AGENDA
PARKS, RECREATION & NATURAL RESOURCES COMMITTEE
MEETING

To: Kris Jenson, Planning Manager

Progressive, LLC is proposing development of 51 dwelling units on 21.3 acres of land located at the southwest corner of Kenwood Avenue (CSAH 50) and Ipava Avenue. The proposed development requires consideration of applications for a Comprehensive Plan amendment guiding the property for a single residential land use category; Zoning Map rezoning portions of the property to RST-2 District; a Conditional Use Permit for Planned Shoreland Development; Preliminary Plat; and Vacation of existing public right-of-way.

PRELIMINARY FLOOD PLAIN IMPACT & MITIGATION PLAN

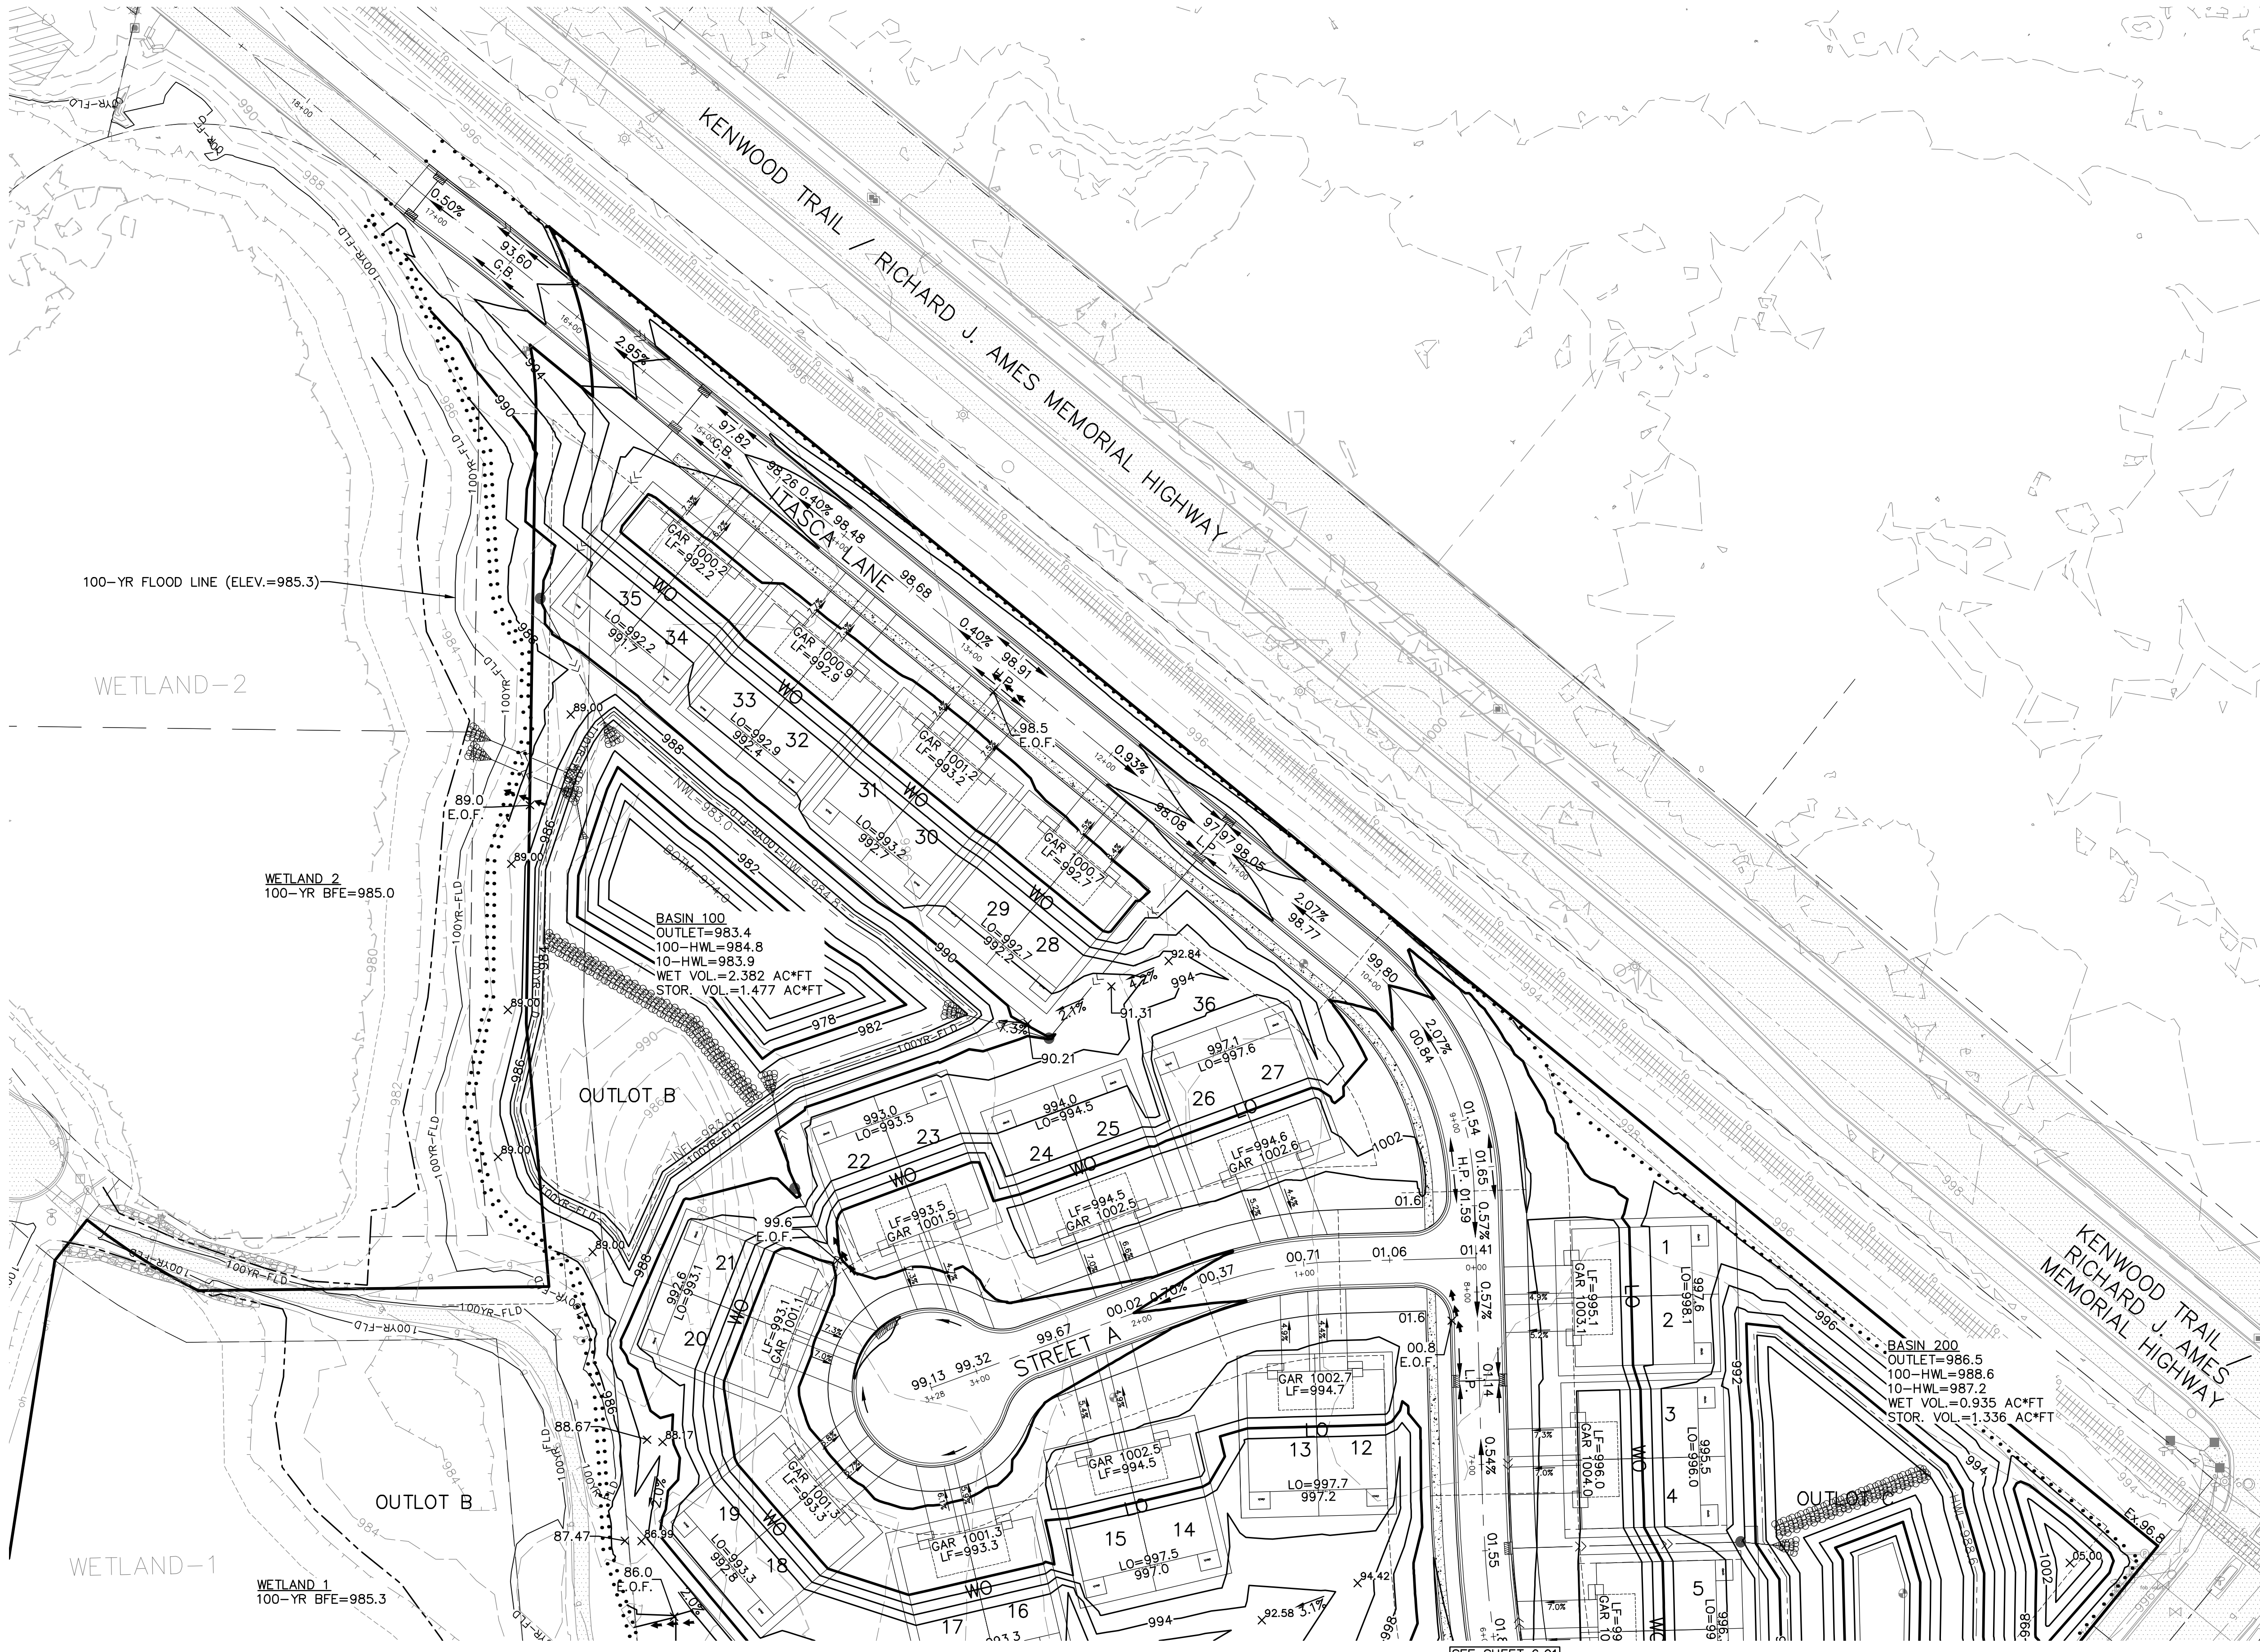
Floodplain. Portions of the subject property are within the 100-year Floodplain, including all of Outlot A. Platting Outlot A as a buildable lot will require that the subdivider demonstrate that the requirements of Section 11-101-13.B of the Zoning Ordinance regarding development standards for floodplain areas complied with. The developer must also verify that the elevation of Italy Avenue complies with Section 11-101-13.E.1 of the Zoning Ordinance providing vehicular access to Outlot A at or above an elevation not more than two feet below the regulatory flood protection elevation for the property to be platted as a buildable lot.

2. Platting of Outlot A as a buildable lot shall be subject to compliance with Title 11, Chapter 101 of the Zoning Ordinance.
3. All right-of-way dedication and street and sidewalk construction plans shall be subject to review and approval of the City Engineer.

LANDSCAPE PLAN

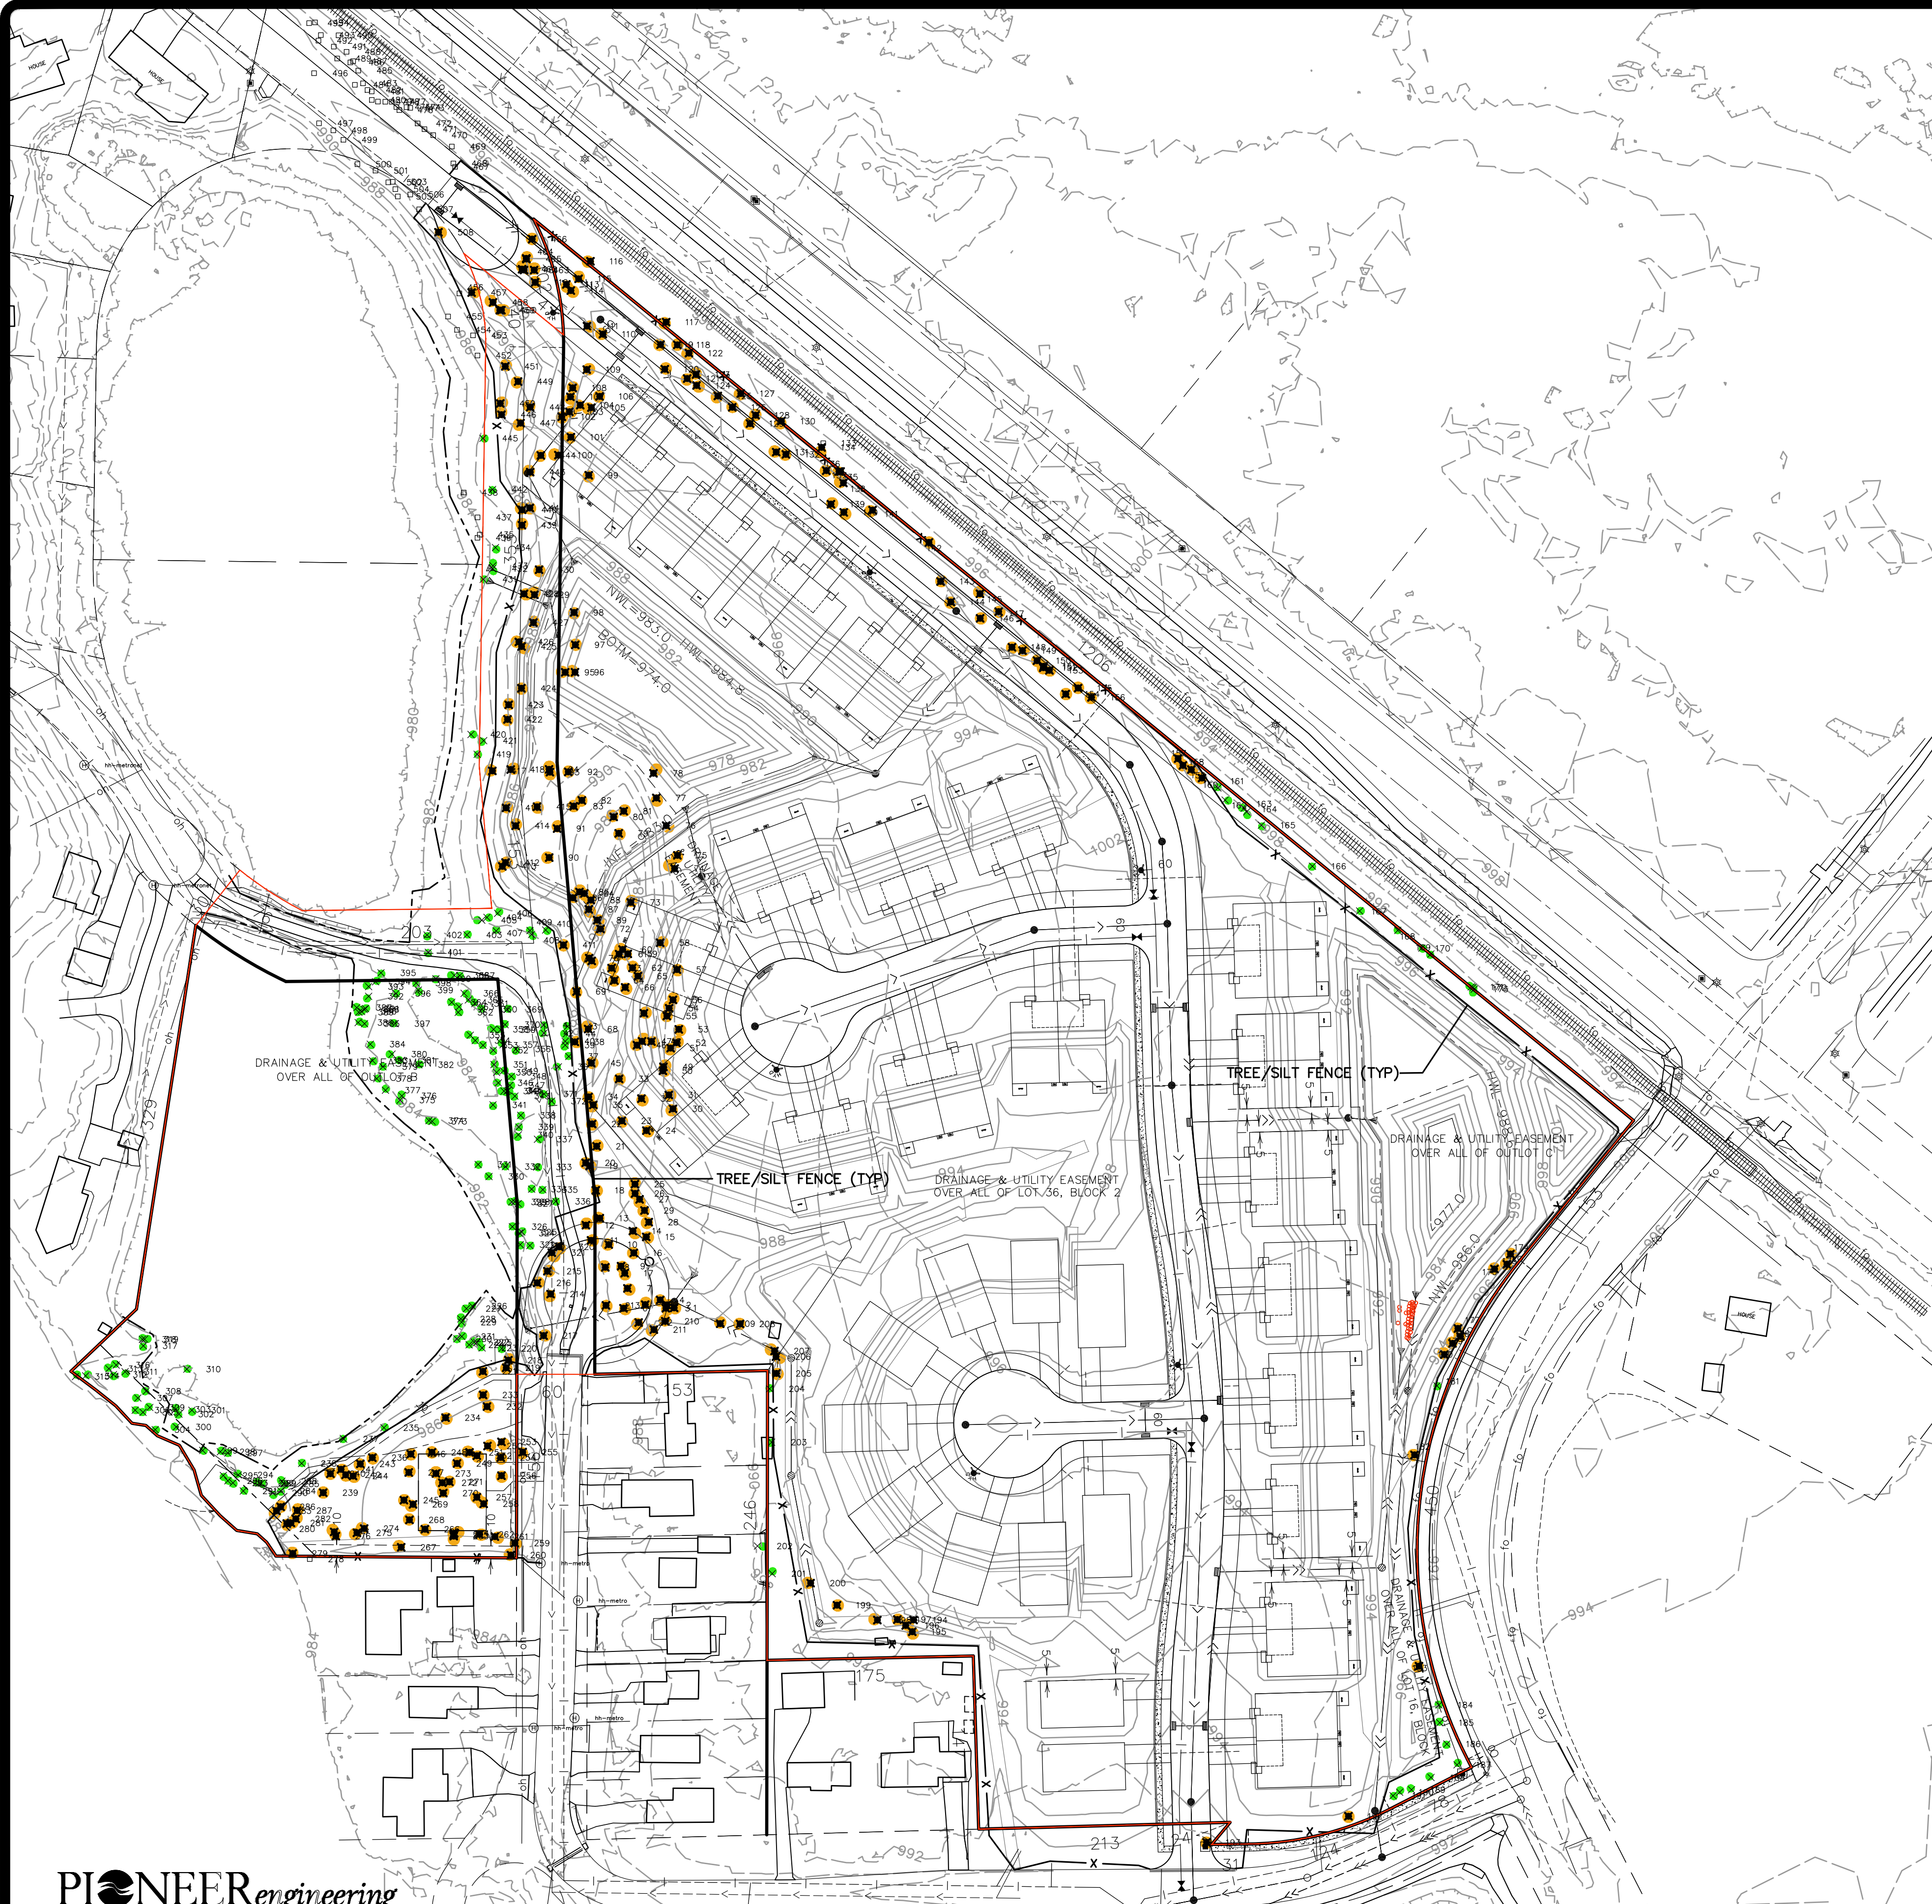
Landscaping. Section 11-57-19.G of the Zoning Ordinance establishes landscape standards for detached townhome and twin home uses within the RST-2 District. A landscape plan has been submitted for the proposed preliminary plat and the City Forester is recommending providing additional tree planting west of Lots 6 and 7, Block 2 to screen from existing houses. The landscape plan must also be revised to provide residential buffer yard planting east of Lots 11-16, Block 1 as required by Section 11-21-9.E of the Zoning Ordinance.

- a. Provide additional tree planting west of Lots 6 and 7, Block 2 to screen from existing houses.
 - b. The landscape plan shall be revised to provide residential buffer yard planting east of Lots 11-16, Block 1 as required by Section 11-21-9.E of the Zoning Ordinance.
